June 2021

Dealer Service Instructions for:

Safety Recall Y36 / NHTSA 21V-398

Wheel Studs

Figure 2A – User’s Guide

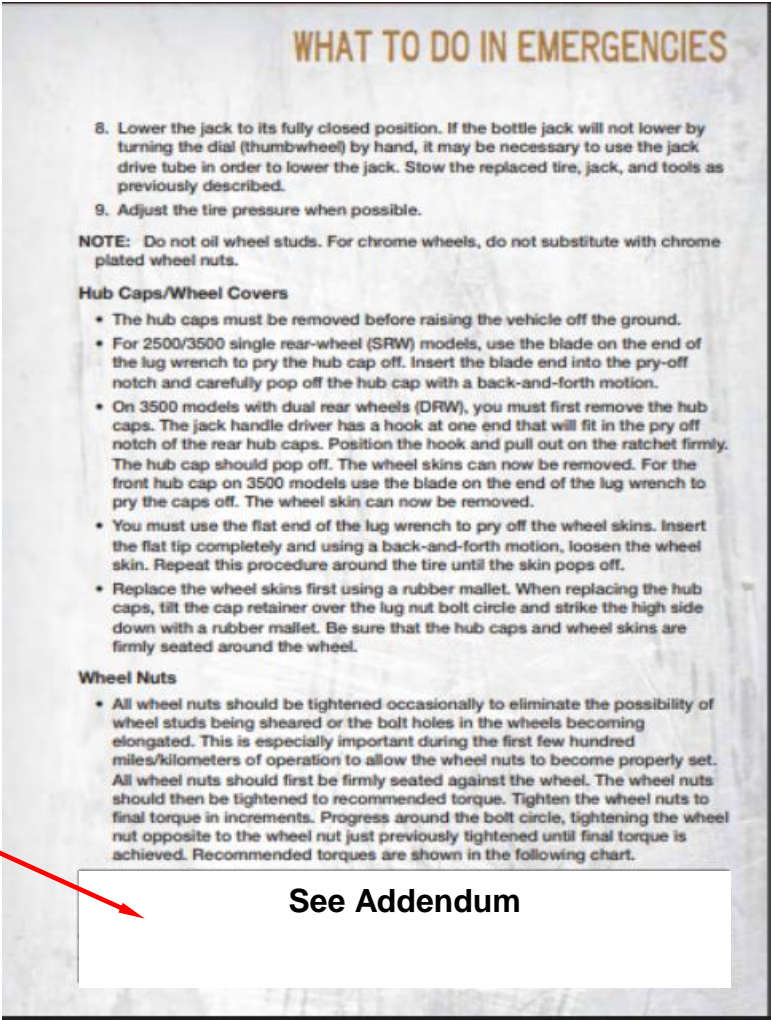
- All wheel nuts should be tightened occasionally to eliminate the possibility of wheel studs being sheared or the bolt holes in the wheels becoming elongated. This is especially important during the first few hundred miles/kilometers of operation to allow the wheel nuts to become properly set. All wheel nuts should first be firmly seated against the wheel. The wheel nuts should then be tightened to recommended torque. Tighten the wheel nuts to final torque in increments. Progress around the bolt circle, tightening the wheel nut opposite to the wheel nut just previously tightened until final torque is achieved. Recommended torques are shown in the following chart.

**ADHERE THE NEW INFORMATION LABEL TO THIS SECTION
PAY SPECIAL ATTENTION TO COVERING THE FLANGED LUG NUT TORQUE 140 FT-LB / 190 N-m.**

Lug Nut/Bolt Torque	Lug Nut/Bolt Type	Lug Nut/Bolt Size	Lug Nut/Bolt Socket Size
130 Ft-Lb (176 Nm)	Cone	M14 x 1.50	22 mm
129 Ft-Lb (175 Nm)	Flanged

NOTE:
 Dual wheels are flat mounted, center piloted. The lug nuts are a two-piece assembly. When the tires are being rotated or replaced, clean these lug nuts at the interface between the lug nut/bolt and the washer. **Do not oil wheel studs.**
